Project Quality Audit

Project: Tengah garden walk (TGW)

Audit Date: 30-Aug-2023

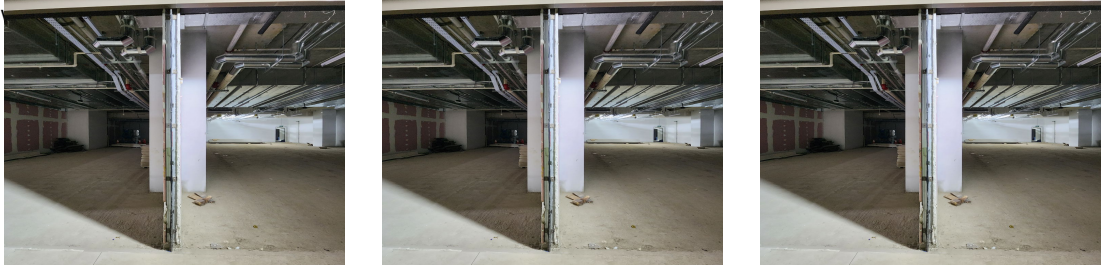
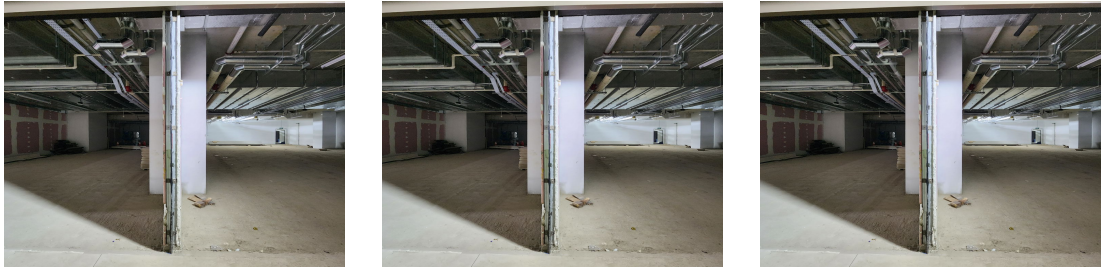
4 Follow-up on last month PQA findings						Weightage (10%)
4.1	Total Findings : 8	Yes : 5	Partial: 2	No : 1	NA: 0	7.5
